Working Party on Brakes and Running Gear

Regulation No. 55 (Mechanical couplings)

Proposal for amendments to Regulation No. 55 (Mechanical couplings)

Submitted by the expert from Germany*

"11. Dedicated drawbar type couplings **—with or without jaw, with or without coupling pin—** Class T

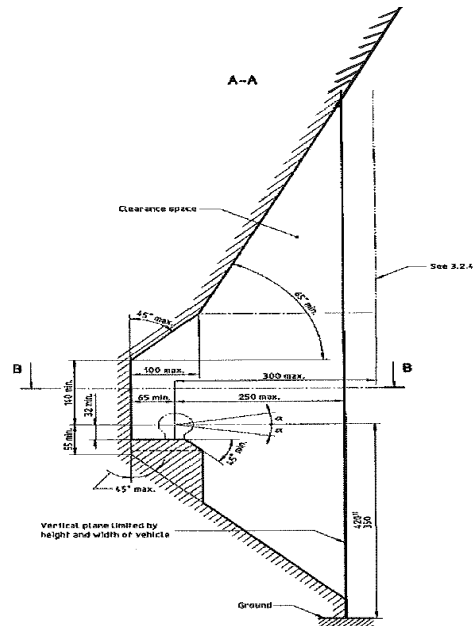
11.1. Class T dedicated drawbar type couplings **—with or without jaw, with or without coupling pin—** are intended for use on specific vehicle combinations, for example, car transporters. These vehicles have special structures and may need particular and unusual location of the coupling."
